Mission Planning and Analysis Division
NATIONAL AERONAUTICS AND SPACE ADMINISTRATION
MANNED SPACECRAFT CENTER
HOUSTON, TEXAS 77058

IN REPLY REFER TO: 70-FM73-328

FROM : FM7/Chairman, Independent Software Review Panel for
Apollo 14

SUBJECT : Final Report for the Apollo 14 Independent Software Review

23. PCR 322

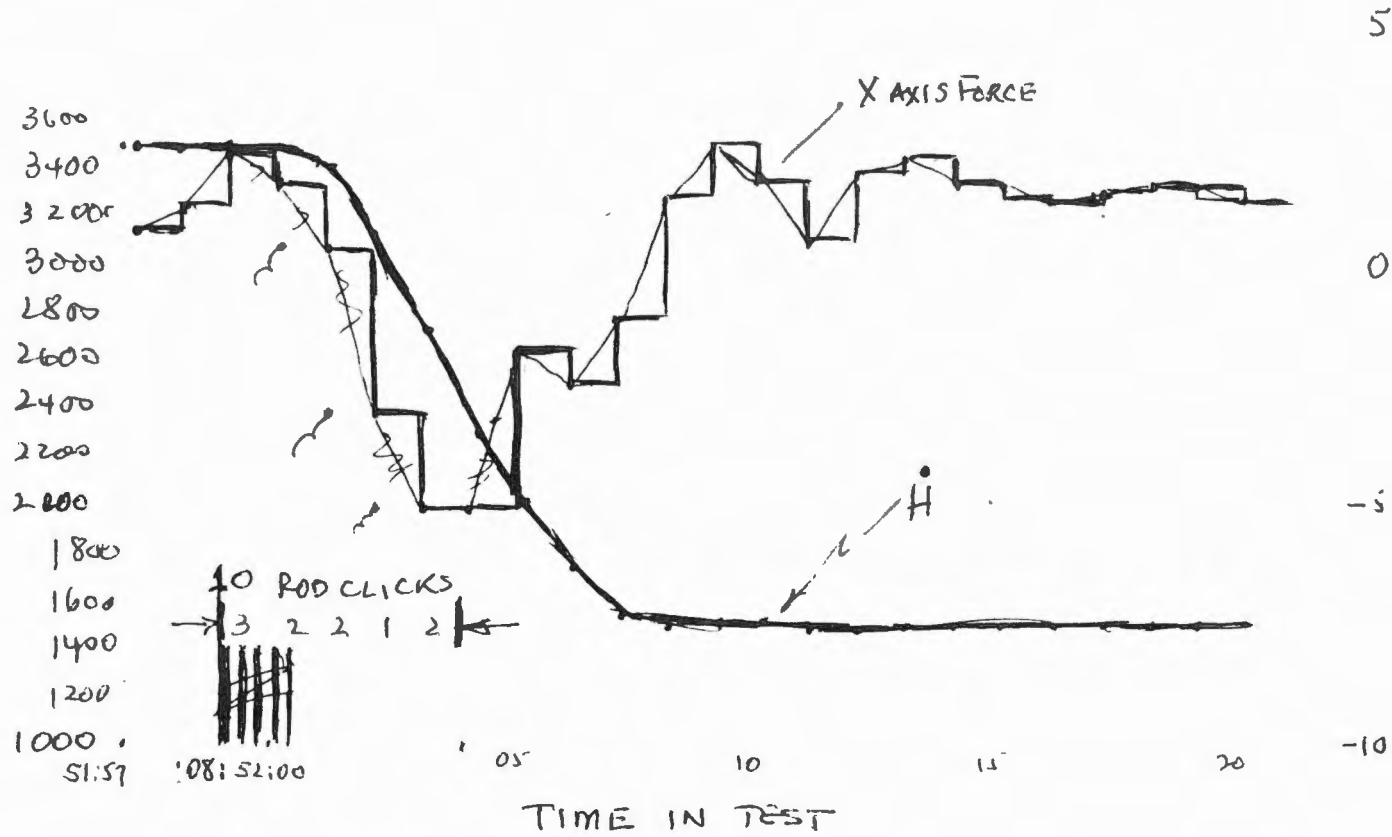
Description: Change THROTLAG from 0.2 to 0.08 sec to improve the throttle stability in P66.

- a. In P66 rapidly enter 2 or 3 ROD clicks. Observe \dot{H} and throttle on downlist for 6 seconds for smooth response.
- b. Change simulator ENVIRONMENT to EQUIVALENT THROTLAG of 0.12 sec and repeat test (a).
- c. Change simulator to 0.04 sec repeat test (a).
- d. Nominal descent. Within 1 second of touchdown enter 1 or 2 up ROD clicks. Observe throttle pulse.

Test Results: The graph plots thrust and \dot{H} vs time in a period in P66 (manual) when 10 ROD clicks were injected in 5 seconds. The thrust response shows a slight oscillation, the \dot{H} response is dead beat. This is very good and indicates the change was properly implemented. Later at 108:54:09 5 ROD clicks were injected of opposite sign in P66 auto. Results were similarly good.
